DEVELOPMENT CONSENT AUTHORITY
ALICE SPRINGS DIVISION

AGENDA ITEM: **1** MEETING DATE: 10/06/2026 FILE: PA2018/0224

APPLICATION PURPOSE: Variation to Condition 3 of DP18/0256

SUBJECT SITE: Units 10998, 10999, 11000, 11001 and 11002
(Subdivision of Lot 179), (80) Hartley Street, Town of Alice Springs. A locality plan is at **Bookmark A**

Figure 1 Reinstated kerbside parking in front of lot on Hartley Street (highlighted yellow) - Proposed Site Plan, prepared by Funarchi, 25/03/2026

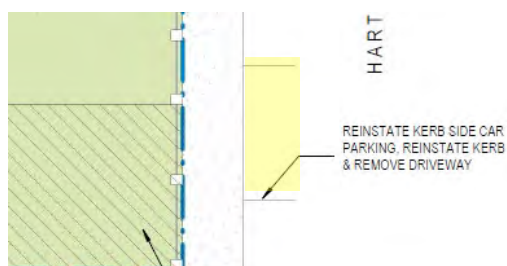
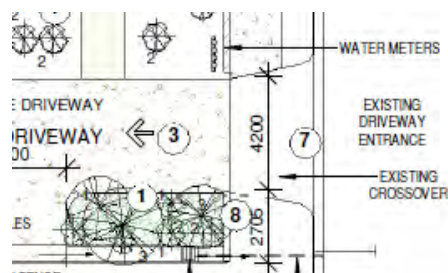
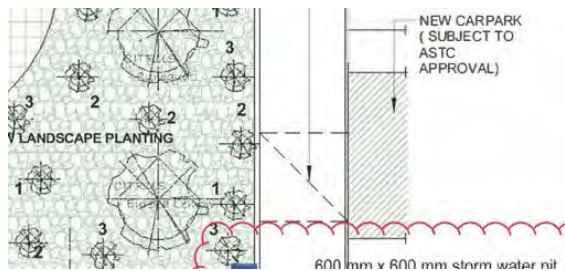
- Removal of Hartley Street vehicle access and reinstate kerbside car parking space.

Figure 4 Reinstate two-way driveway - Proposed Site Plan, prepared by Funarchi, 25/03/2026

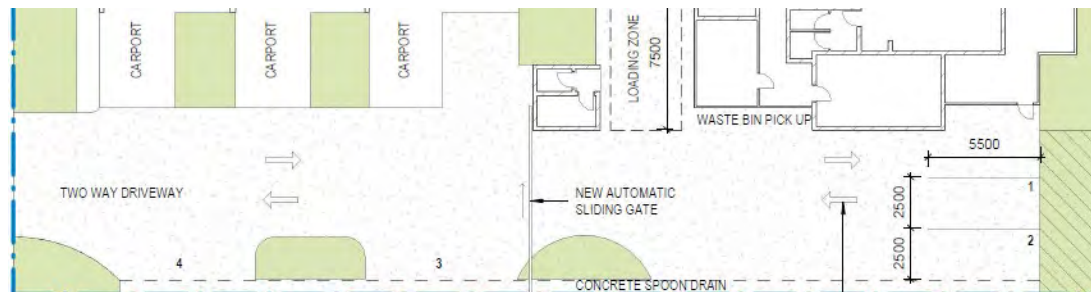
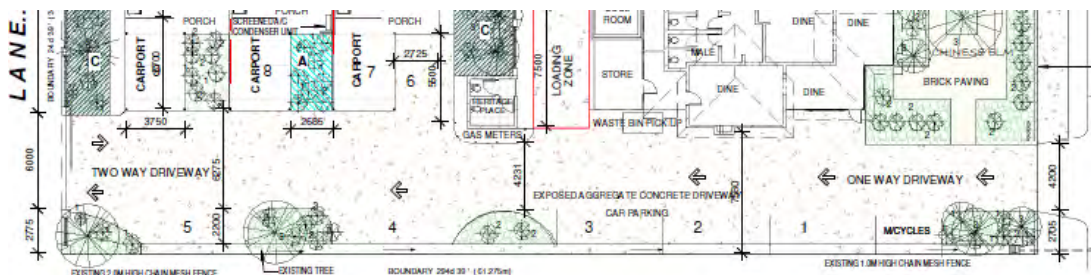
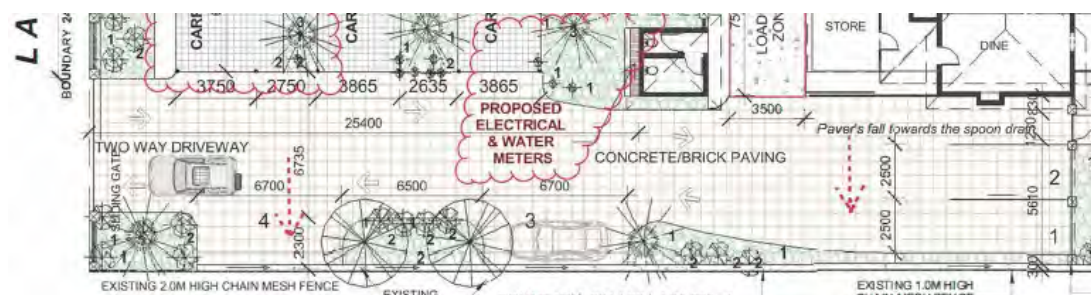
- Two-way driveway from rear laneway.

Figure 7 Landscaping to southern boundary of lot in place of driveway to Hartley Street – Proposed Site Plan, prepared by Funarchi, 25/03/2026

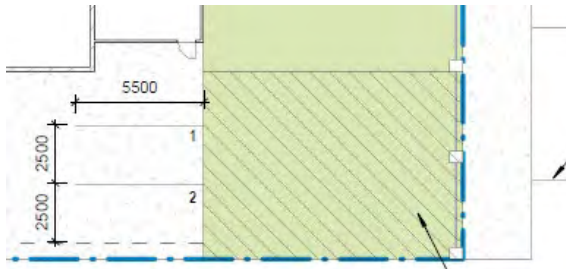
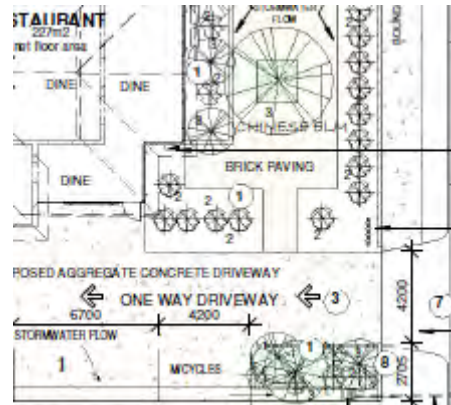
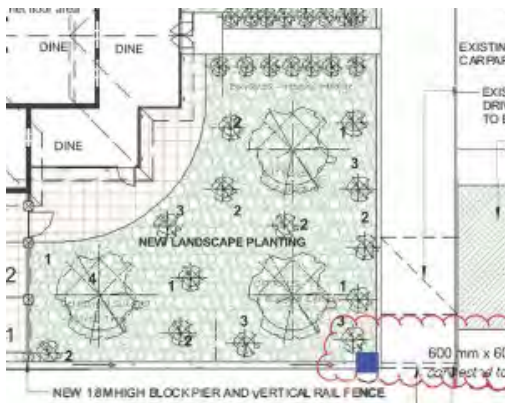
- Landscaping to the southern boundary in place of driveway- Hartley Street frontage

Figure 10 Proposed removal of Hartley Street access and reinstatement of 2 right angle parking spaces (highlight yellow), Proposed Site Plan, prepared by Funarchi, 25/03/2026

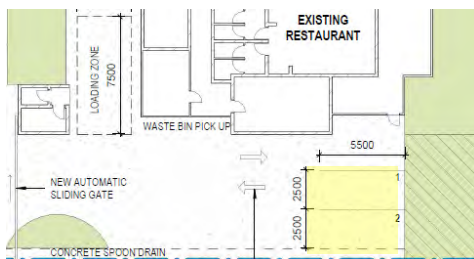
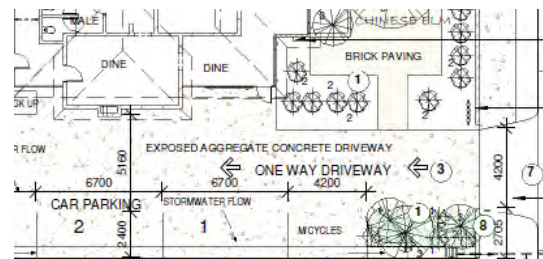
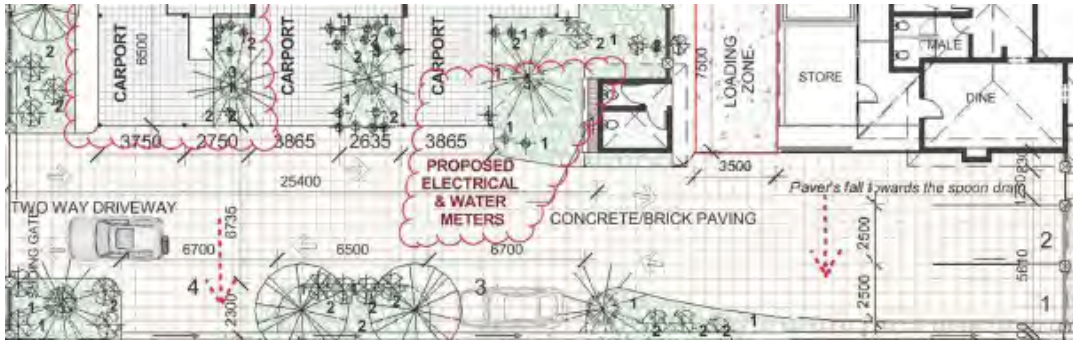
- Reinstate car parking spaces 1 and 2 located at the Hartley Street end of the internal driveway.

Figure 16 Garden bed and driveway, west of existing loading zone (highlighted yellow)- Endorsed Drawing No. PA2018/0224/A1

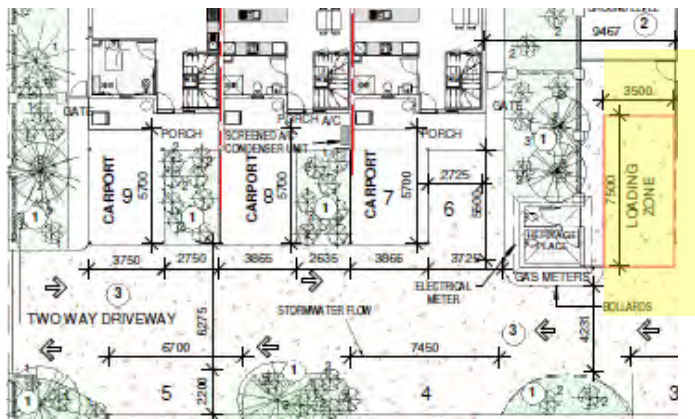
- Garden bed and driveway layout west of the existing loading zone.

Figure 17 Proposed Automatic sliding gate (highlighted yellow) – Proposed Site Plan, prepared by Funarchi, 25/03/2026

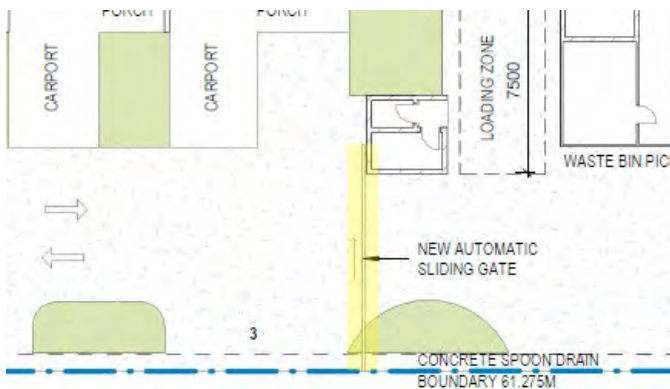
- Automatic sliding gate across the driveway between unit 3 and the freestanding amenities block.

Figure 20 Amended plans addressing Condition Precedent 1, submitted for endorsement and showing changes to driveway surfacing, Drawing No. A02, prepared by Steve Adler Building Design, dated 27/09/2018

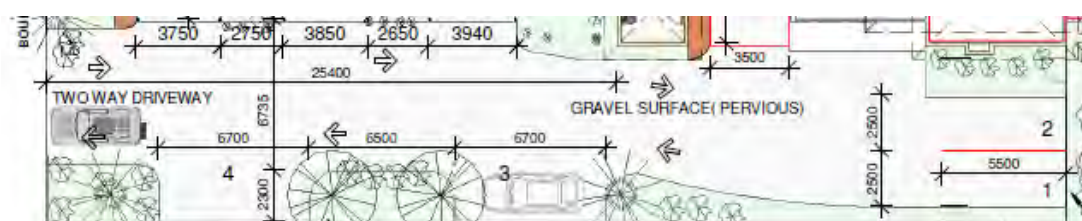
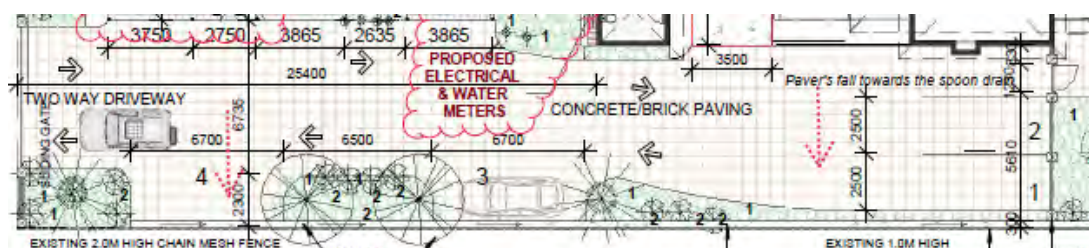
- The Statement of Effect submitted as part of PA2018/0224 sought a variation to sub-clause 3(b) noting that the surface of the driveway and car parking areas would remain a gravel surface consistent with the guidance contained within the Management Plan for the Heritage Precinct and previous planning approval DP14/0434 for Lot 179 that granted a variation to this Clause. This was reiterated in Development Assessment Services agenda report to the Development Consent Authority (DCA) for its meeting held on 11 July 2018. Contrary to this, amended plans addressing Condition Precedent 1 and endorsed under DP18/0256, showed a change to the driveway from gravel to concrete/brick pavers.
